ISSUE FOR MODIFICATION 4.55
HOUSEHOLD BINS LOCATION REVISED
ISSUE FOR DA
ISSUE TO CONSULTANTS - REDUCED HOUSE AREAS
ISSUE TO CONSULTANTS

PROJECT NO. 2102
DATE October 2021
SCALE 1:100

A.05
D

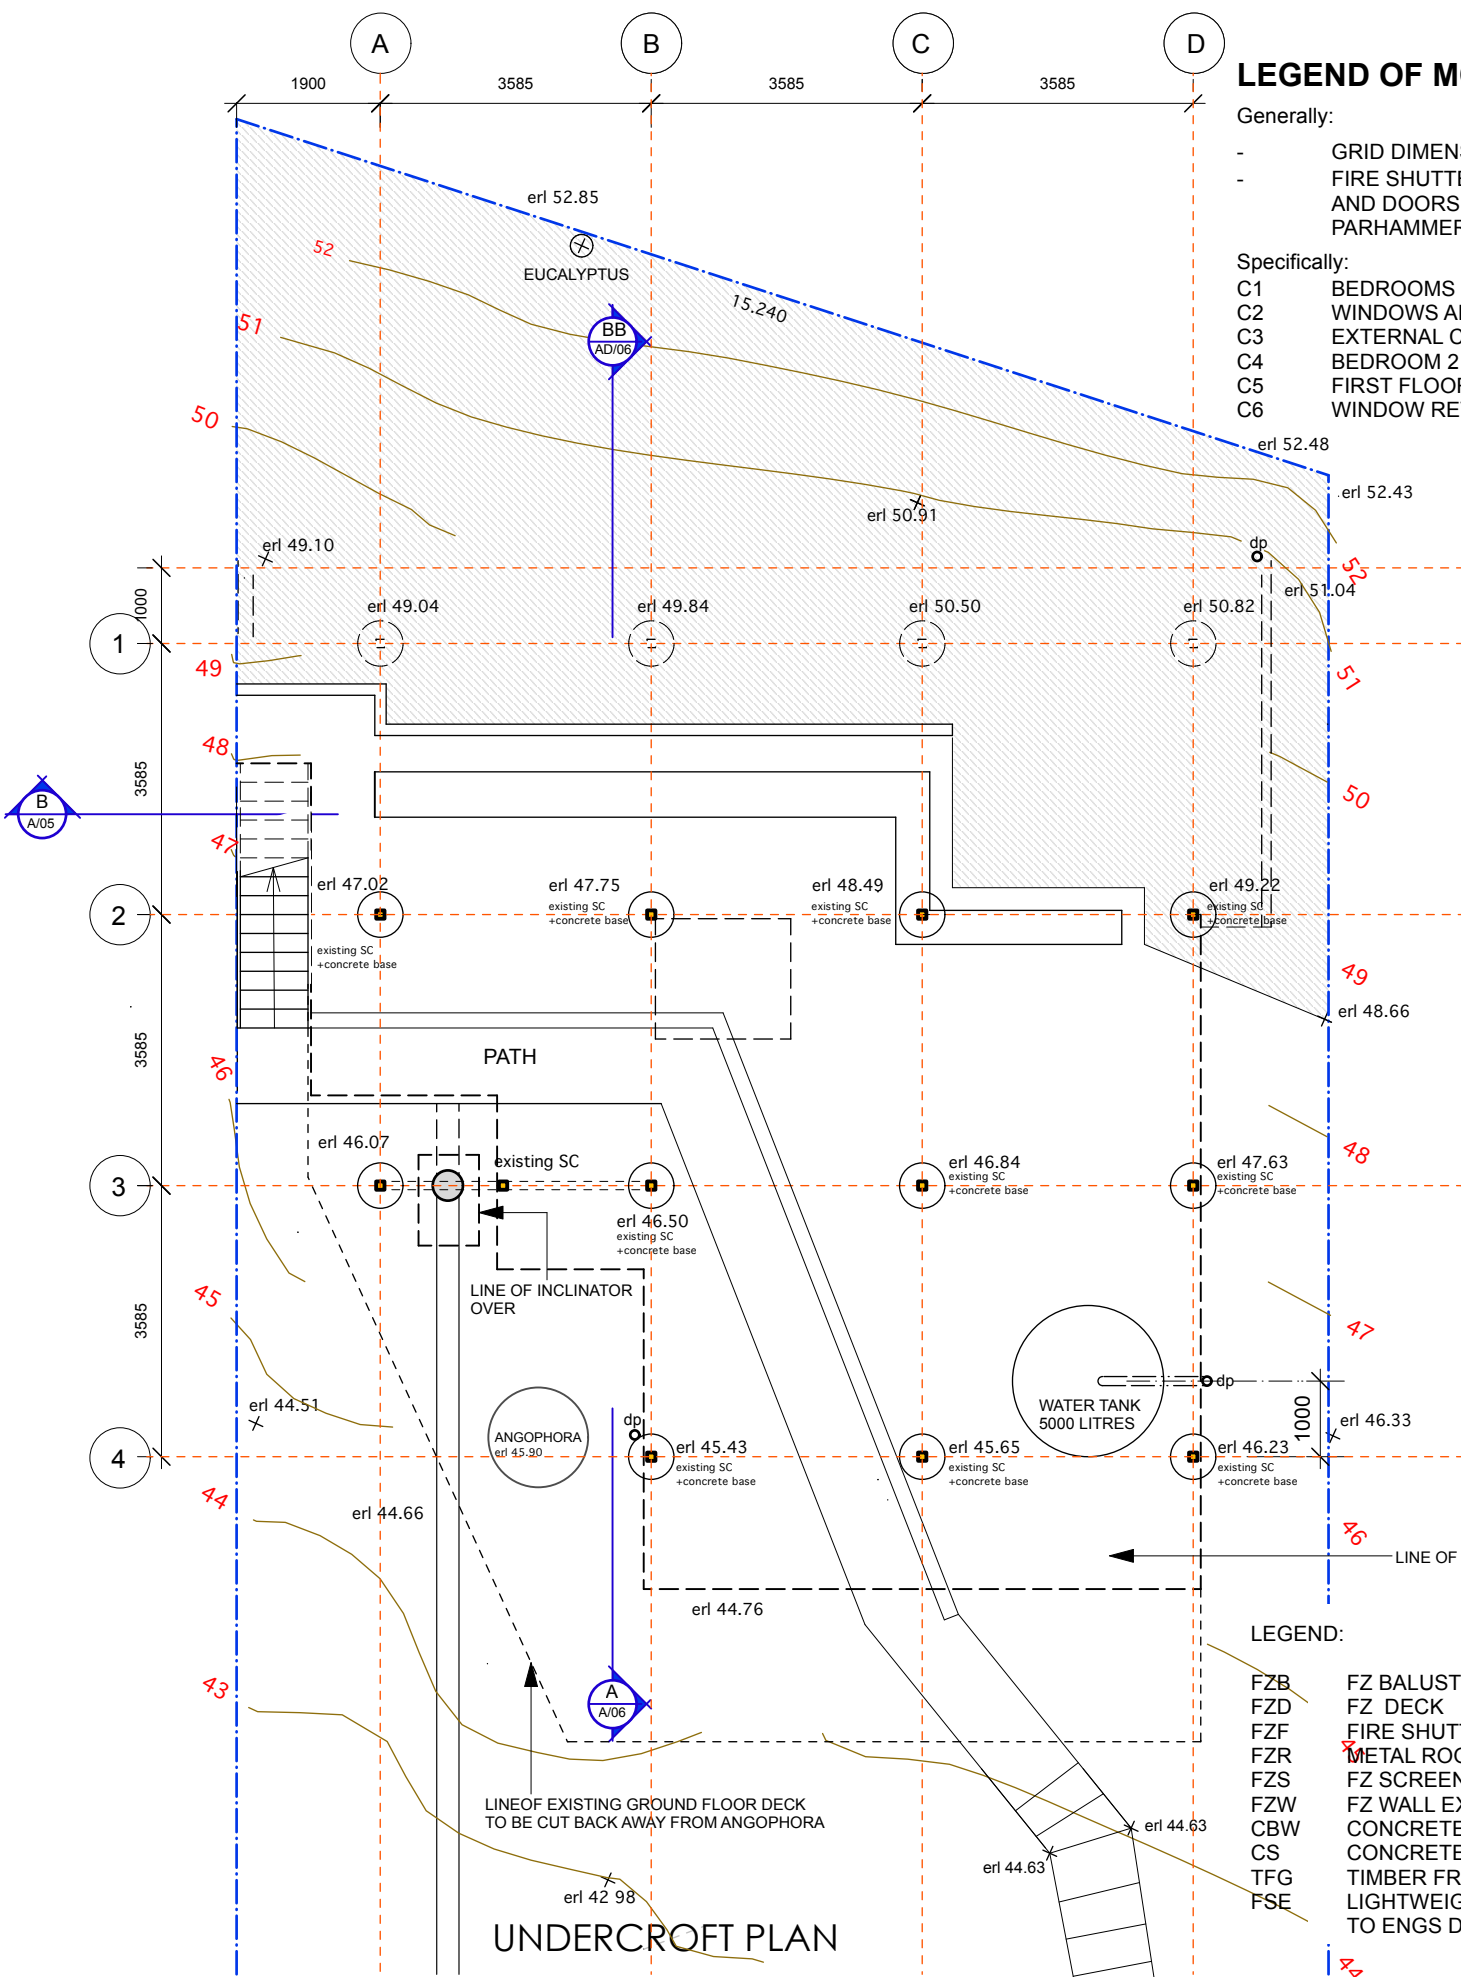
- Generally:
- GRID DIMENSIONS ADJUSTED
 - FIRE SHUTTERS DELETED AND EXTERNAL WINDOWS AND DOORS TO BE FZ RATED SIMILAR + EQUAL TO PARHAMMER
- Specifically:
- C1 BEDROOMS 3 + 4 SLIDING DOORS RELOCATED IN WALL
 - C2 WINDOWS ADDED
 - C3 EXTERNAL CORNER REVISED
 - C4 BEDROOM 2 NORTH WALL MOVED
 - C5 FIRST FLOOR DECK REVISED
 - C6 WINDOW REVISIONS

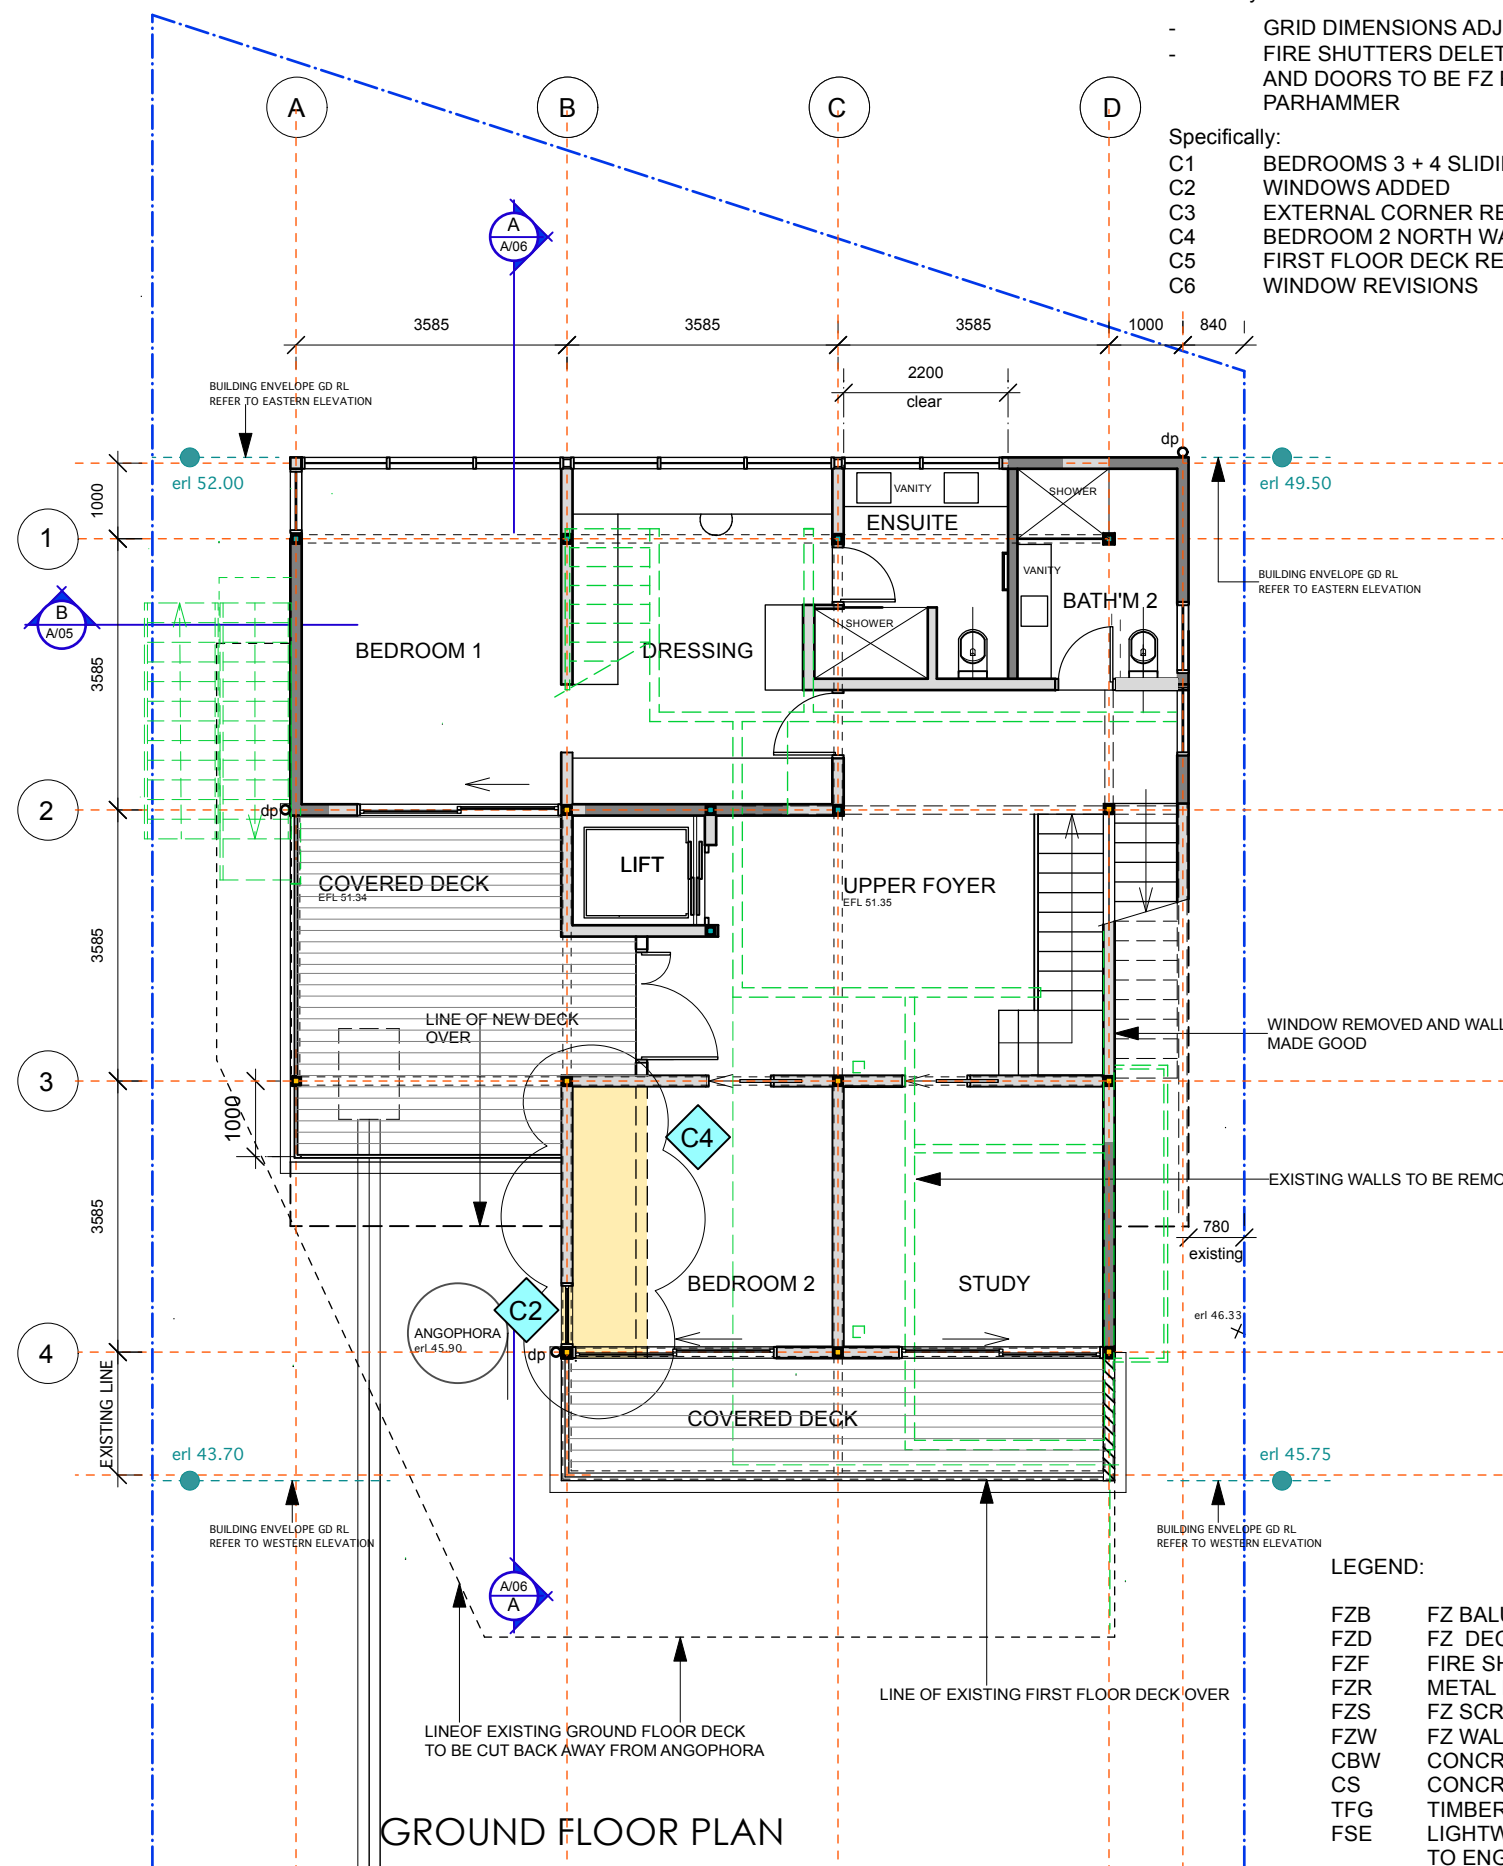
- GRID DIMENSIONS ADJUSTED
- FIRE SHUTTERS DELETED AND EXTERNAL WINDOWS AND DOORS TO BE FZ RATED SIMILAR + EQUAL TO PARHAMMER

- C1 BEDROOMS 3 + 4 SLIDING DOORS RELOCATED IN WALL
- C2 WINDOWS ADDED
- C3 EXTERNAL CORNER REVISED
- C4 BEDROOM 2 NORTH WALL MOVED
- C5 FIRST FLOOR DECK REVISED
- C6 WINDOW REVISIONS

ROOF PLAN

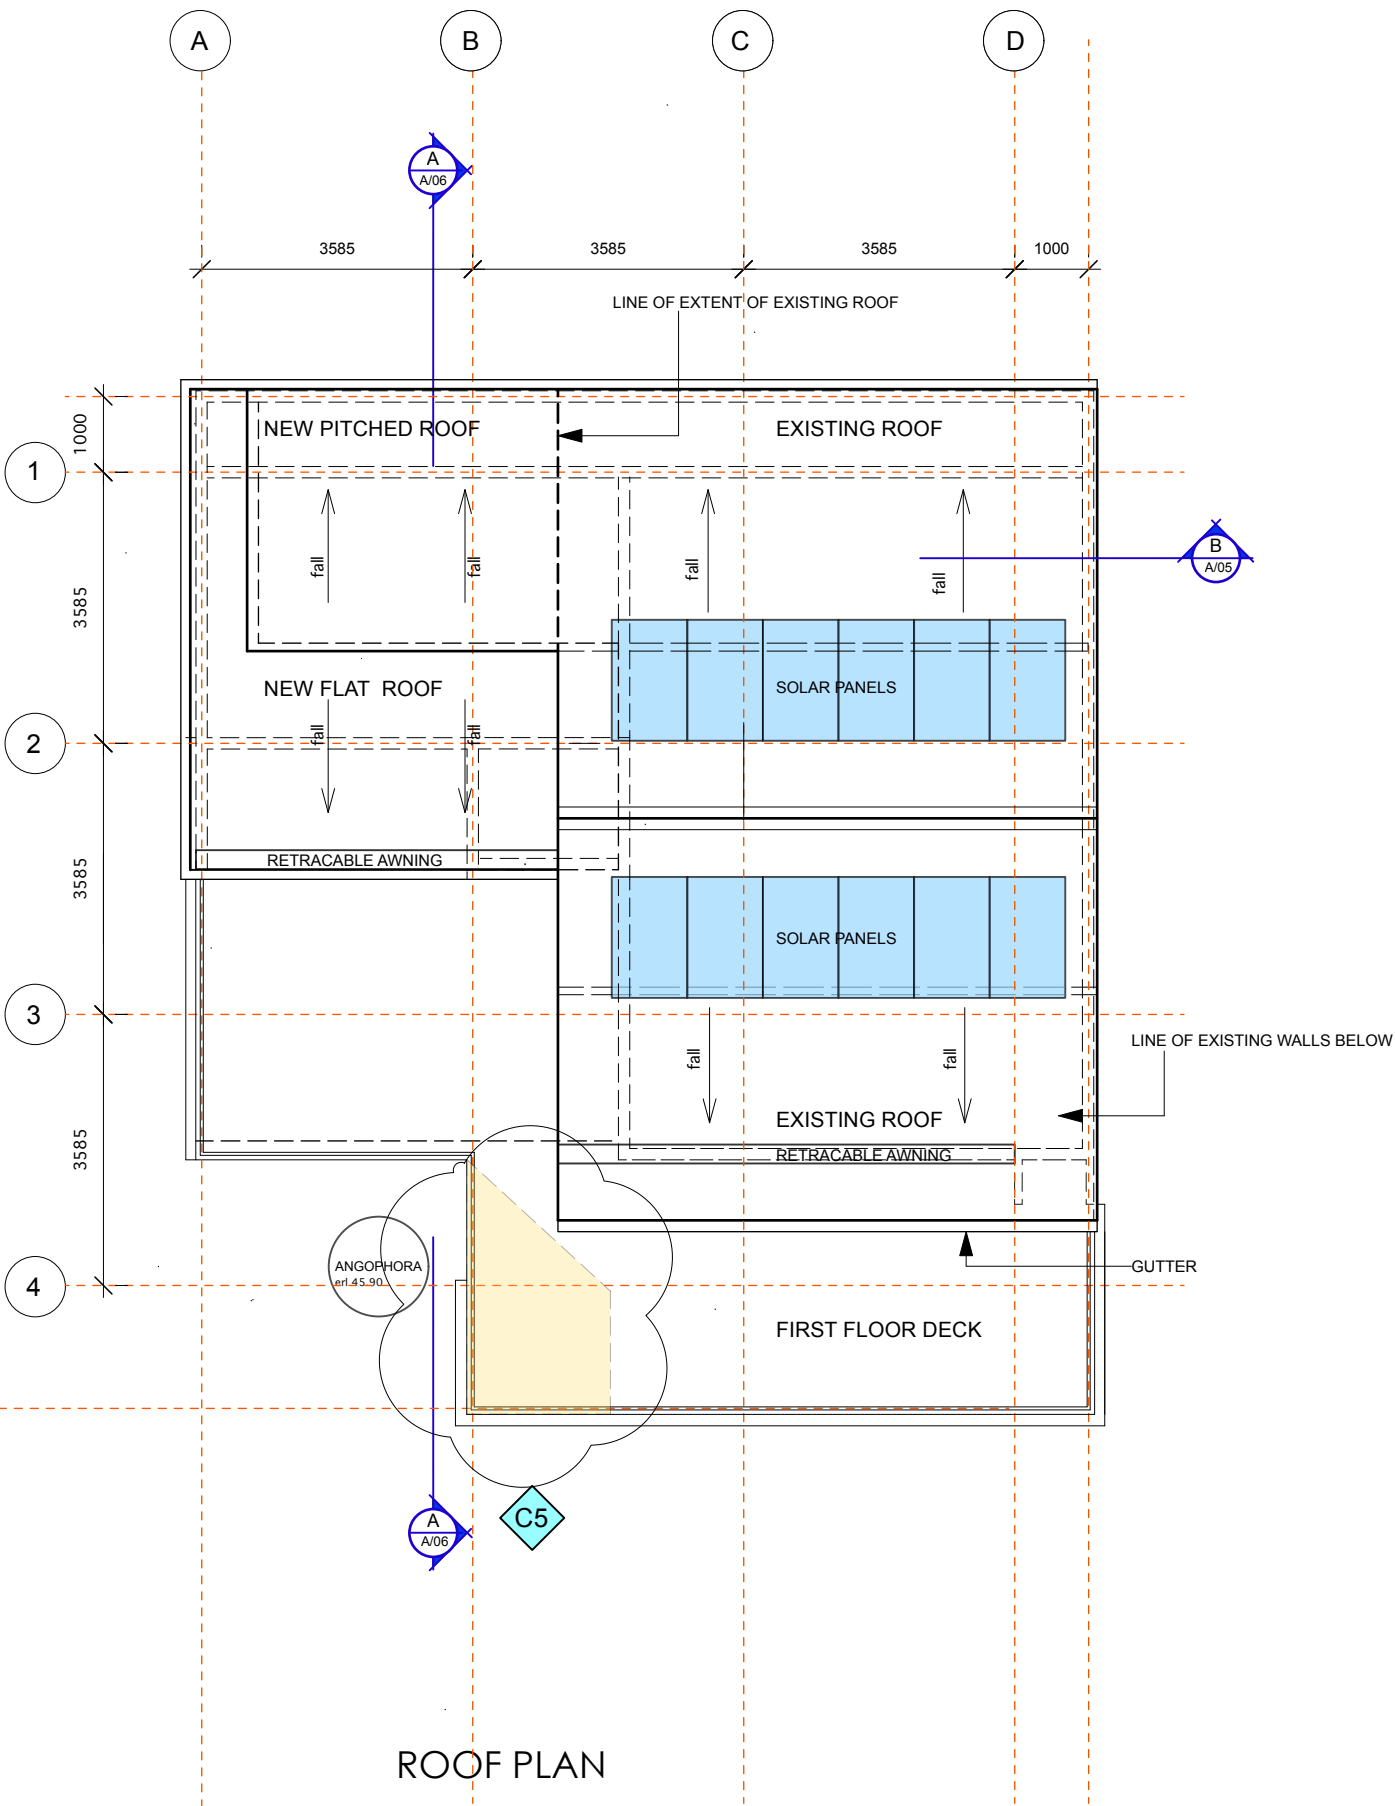
- GRID DIMENSIONS ADJUSTED
- FIRE SHUTTERS DELETED AND EXTERNAL WINDOWS AND DOORS TO BE FZ RATED SIMILAR + EQUAL TO PARHAMMER

C1	BEDROOMS 3 + 4 SLIDING DOORS RELOCATED IN WALL
C2	WINDOWS ADDED
C3	EXTERNAL CORNER REVISED
C4	BEDROOM 2 NORTH WALL MOVED
C5	FIRST FLOOR DECK REVISED
C6	WINDOW REVISIONS
